Date April 3, 2024 **Report No.** 2024-202

Committee of Adjustment Decision Regarding Applications for Consent and Minor Variance

APPLICATION NO.: B16-2024, A16-2024

LOCATION: 29 Elm Street

Figure 1 - Severance Sketch

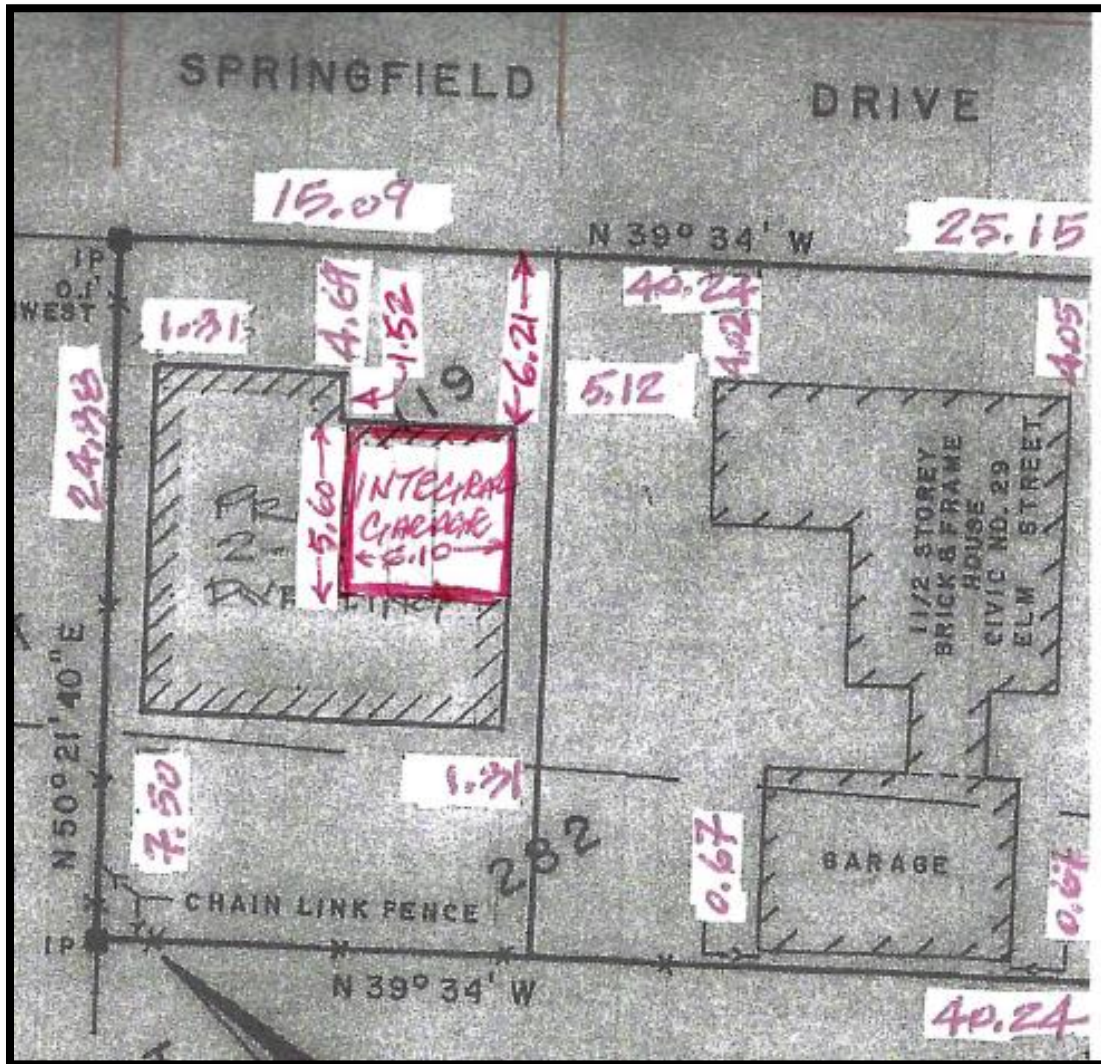
Transportation Department staff commented that prior to obtaining permits, the location of the proposed driveway/garage must be established. Detailed parking/driveway dimensions for the severed parcel are required. Staff will not endorse a front yard setback less than 6 m. A daylight triangle measuring 4.5 m must be conveyed to the public roadway at the corner nearest the intersection of Elm Street and Springfield Drive, along with 0.3 m reserves. No driveways should be located closer than 9.2 m along the lot line from the nearest side of the driveway to the road allowance of the intersecting road. For the severed lot accessing Springfield Drive, a minimum 6 m front yard is necessary to accommodate a driveway. These will also be required if the consent application is approved.

Building Department staff stated that spatial separation calculations are necessary for the reduced rear yard setback. The location of the proposed parking space (driveway or garage) needs clarification. An integral garage or carport is required to reduce side yard setbacks to 1 m, per 7.3.2.7(1) of the Zoning By-law. Upon receiving this comment, Planning Staff gained clarity through the revised concept drawing, shown in **Figure 1**.

In addition, the front yard of 4.69 m is being attributed to the retained property; however, from the drawing, it should be attributed to the severed property?

4. The **severed** lot is proposed to have a **front yard setback** (Springfield Drive) of 4.69 m instead of the minimum 6 m. It appears the front of the proposed house is intended to align with the **side** of the retained house. The retained house 'fronts' on Elm Street. Given that the new house is proposed to 'front' on Springfield Drive, it should be required to match the setback of those houses existing on Springfield Drive or, at the very least, provide the minimum 6 m. Our property – adjacent to the proposed severed lot – has a front yard setback of 7.4 m., which is typical for Springfield Drive.
